FILE: 09-AFC-08

PROJECT TITLE: Genesis Solar Energy Project

<input checked="" type="checkbox"/> Email	mdaly@psomas.com	<input type="checkbox"/> Meeting Location:	
NAME:	Mike Daly, PE Genesis Water Analyst Senior Project Manager, PSOMAS	DATE:	2-09-10
		TIME:	10:00 a.m.
		DOCKET	
WITH:	Bob Anders, Dipti Sheth (Worley Parsons)	09-AFC-8	
SUBJECT:	Genesis Surface Drainage Data Requests	DATE	<u>02/09/10</u>
		RECD.	<u>02/11/10</u>

FORD DRY LAKE – 5-YR COMBINED OUTFLOW

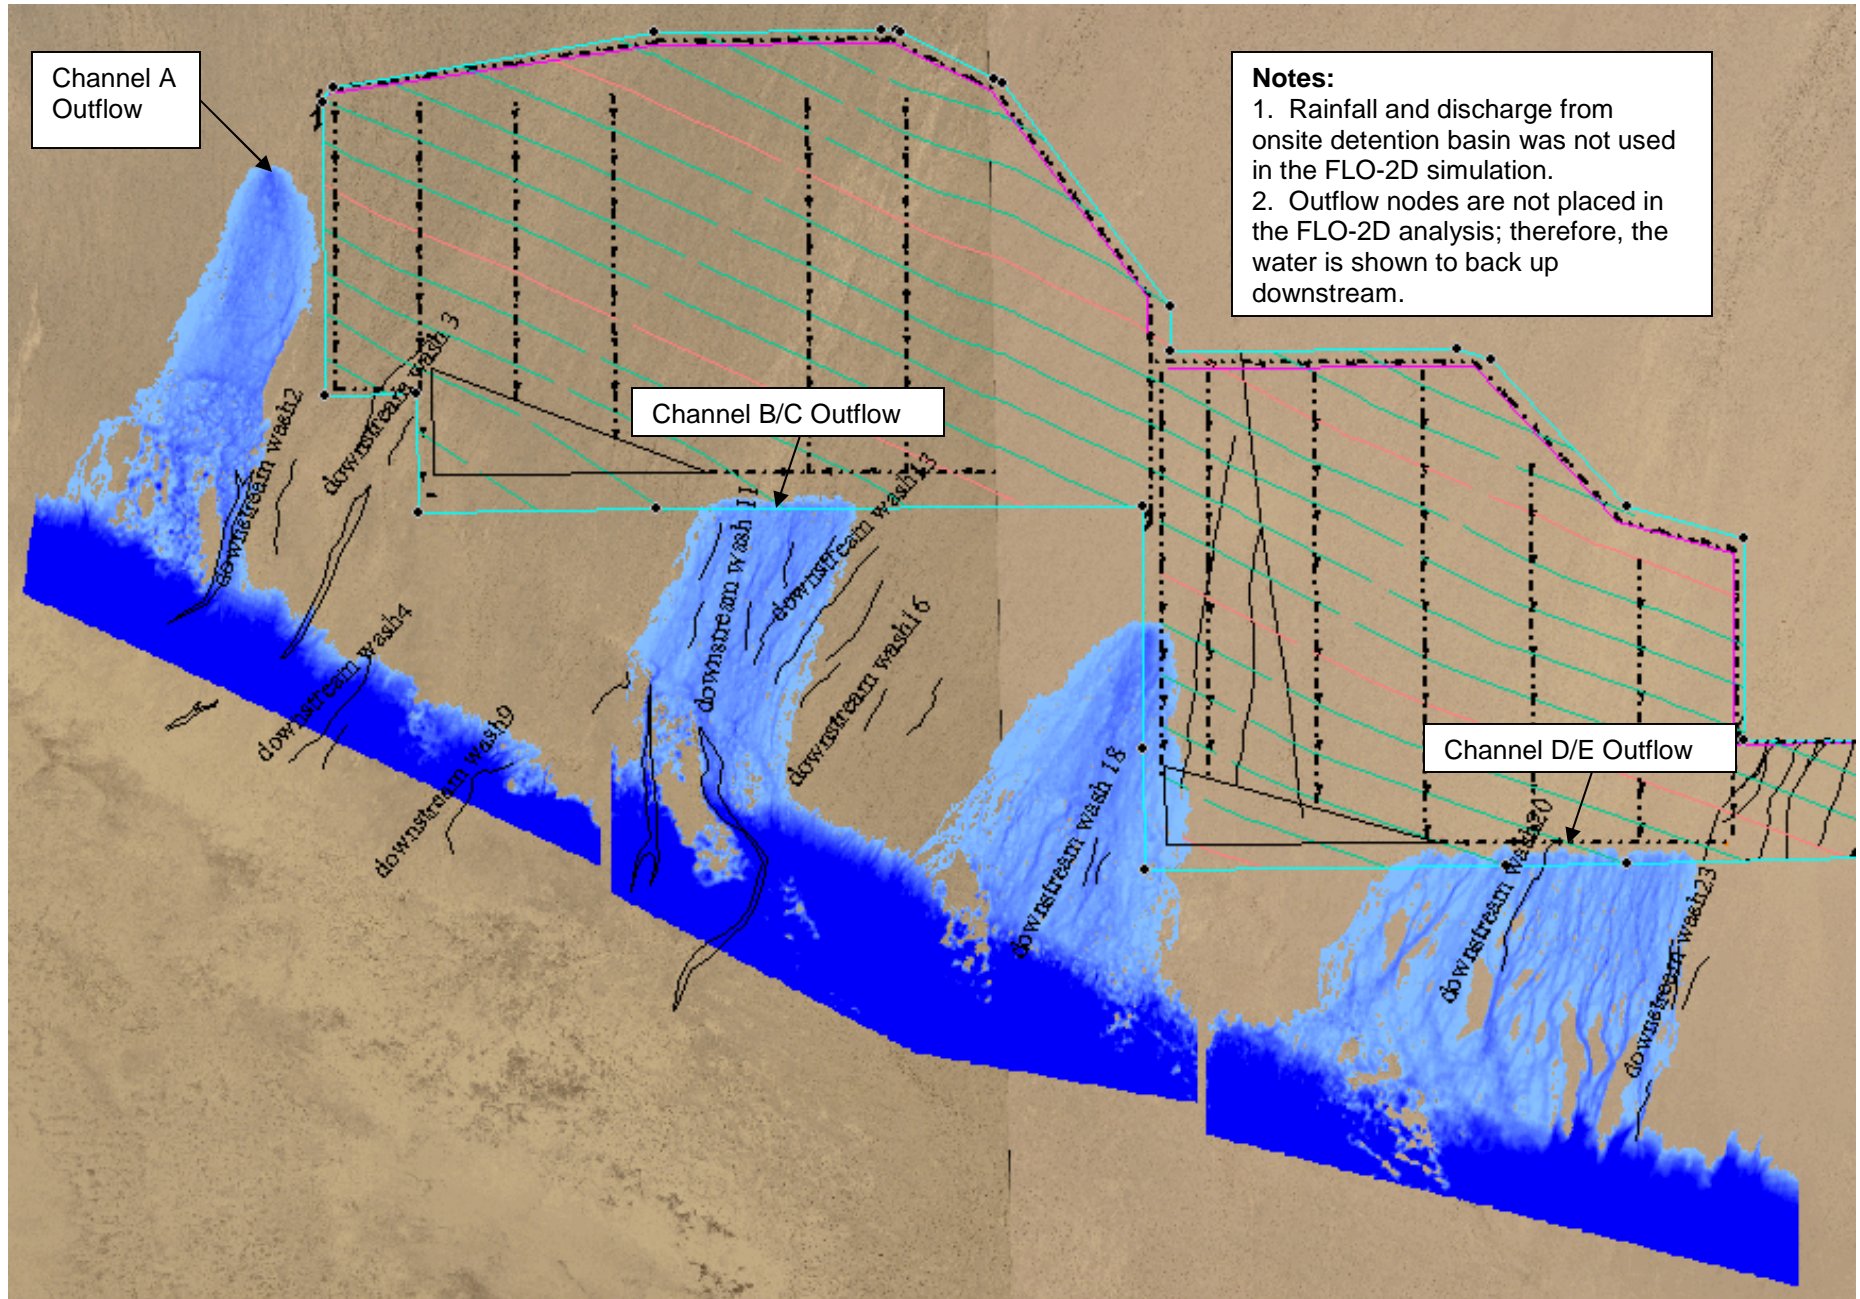
Based on the conversation, Dipti prepared a revised FLO-2D figures showing the FLO-2D results superimposed over the State Waters delineation. Copies of these figures have been attached.
